Access Compliance Report

Public Rights-of-Way

(Curb Ramps)

Intersection ID: N/A	Main Street: ROCK_ISLAND_RD	Cross Street: AGNEW_DR	Location: SE
ADA ID: 094F747B2221	Ramp Type: Perp	Initial Pass/Fail: Fail	Overall Compliance: No
		Severity Score: 25

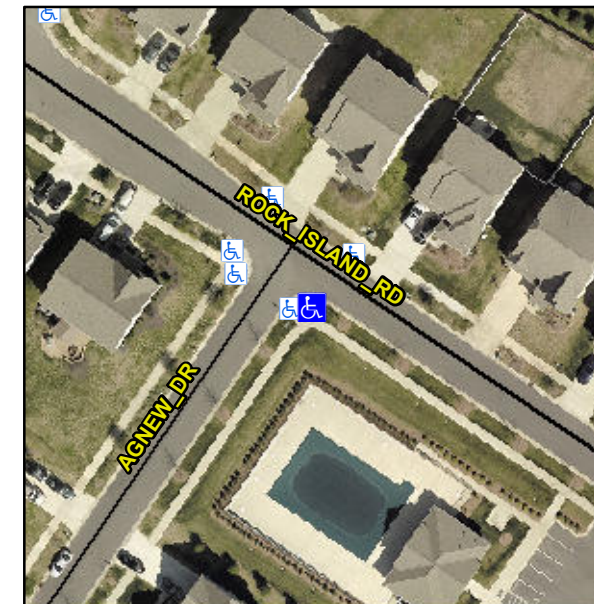
Not Found, R304.5.3

Compliance	Description	Data	Compliance	Description	Data
N/A	Ramp Length (in)	105.0	Yes	Ramp Slope (%)	6.0
Yes	Ramp Width (in)	48.0	No	Ramp XSlope (%)	8.0
N/A	Flare Type LT	N/A	N/A	Flare Type RT	N/A
N/A	Flare Slope LT (%)	N/A	N/A	Flare Slope RT (%)	N/A
N/A	Flare Traversable LT?	N/A	N/A	Flare Traversable RT?	N/A
N/A	Landing Length (in)	N/A	N/A	DWS Provided?	N/A
N/A	Landing Width (in)	N/A	N/A	DWS Contrast?	N/A
N/A	Landing Slope (%)	N/A	N/A	DWS Length (in)	N/A
N/A	Landing X Slope (%)	N/A	N/A	DWS Full Width?	N/A
N/A	Landing Curb? (Y/N)	N/A	N/A	DWS Offset (in)	N/A
N/A	Shared Landing?	N/A			
N/A	Gutter Ponding?	N/A	N/A	Gutter Slope (%)	N/A
N/A	Gutter Lip Ht (in)	N/A	N/A	Gutter X Slope (%)	N/A
N/A	Painted X Walk1?	No	N/A	Painted X Walk2?	N/A
	X Walk 1 Direction	To NE		X Walk 2 Direction	N/A
N/A	X Walk 1 Width (in)	N/A	N/A	X Walk 2 Width (in)	N/A
	X Walk 1 Slope (%)	2.7		X Walk 2 Slope (%)	N/A
	X Walk 1 X Slope (%)	8.7		X Walk 2 X Slope (%)	N/A

Remove & Replace Entire Ramp.
